HYUNDAI Technical Service Bulletin	GROUP FUEL SYSTEM	NUMBER 20-FL-001H
	DATE February, 2020	MODEL(S) ELANTRA (AD/ADA)
SUBJECT:	DTC P0300/P0301/P0302/P0303/P0304 ECM SOFTWARE UPDATE AND IGNITION COIL INSPECTION/REPLACEMENT

This TSB supersedes TSB 19-FL-006H-1 with revised ECM software update and ignition coil external body appearance information.

SUBJECT: DTC P0300/P0301/P0302/P0303/P0304 ECM SOFTWARE UPDATE AND IGNITION COIL INSPECTION/REPLACEMENT

Older Style Ignition Coil External Body Appearance:

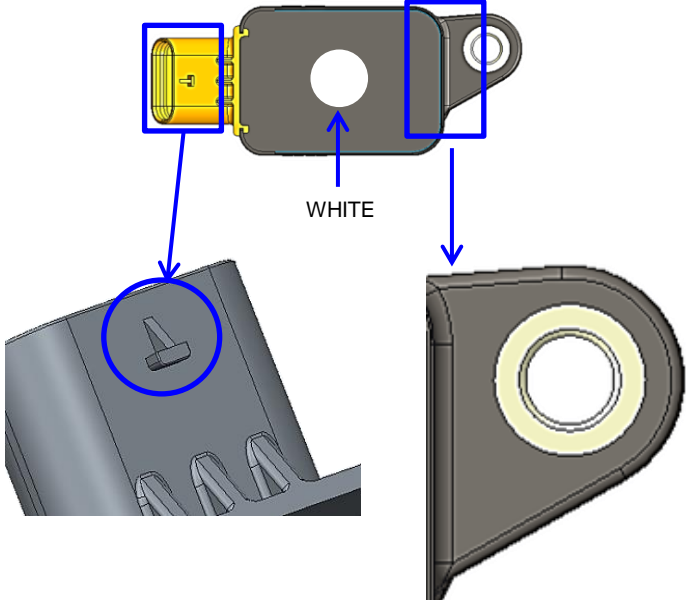
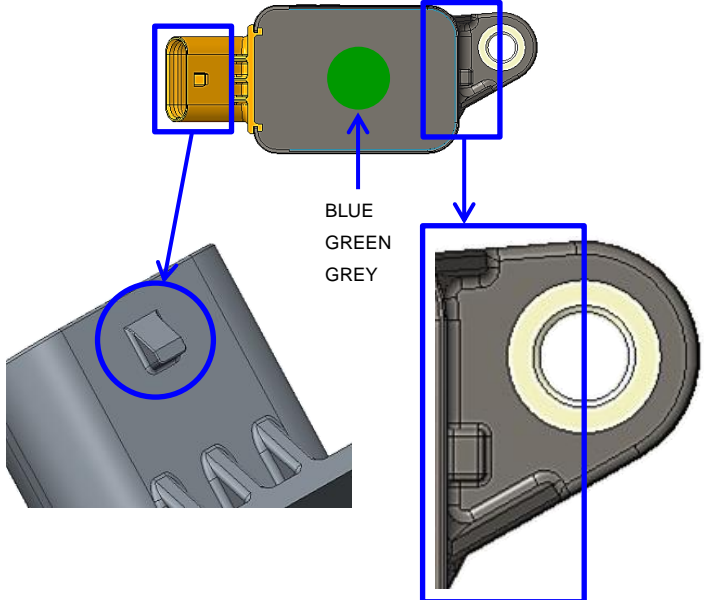
PART NAME	PART NUMBER	REMARKS
IGNITION COIL	<p style="text-align: center;">27300-2E601</p> <div style="display: flex; justify-content: space-around;"> <div style="text-align: center;"> <p>Older Style</p>  <p>Replacement ignition coil with previous shaft design</p> </div> <div style="text-align: center;"> <p>Newer Style</p>  <p>Replacement ignition coil with updated shaft design</p> </div> </div>	<ul style="list-style-type: none"> Both the older and newer ignition coil shaft styles are interchangeable. Color marking inspection does not apply to the newer style ignition coil with updated shaft design. Replace if the vehicle ignition coil is the older style and has a WHITE or BLUE mark on top. Do not replace if the vehicle ignition coil is the older style and has a GREEN or GREY mark on top.

Older Style Ignition coil with WHITE Mark	Older Style Ignition coil with BLUE/GREEN/GREY Mark
 <p style="text-align: center;">WHITE</p>	 <p style="text-align: center;">BLUE GREEN GREY</p>
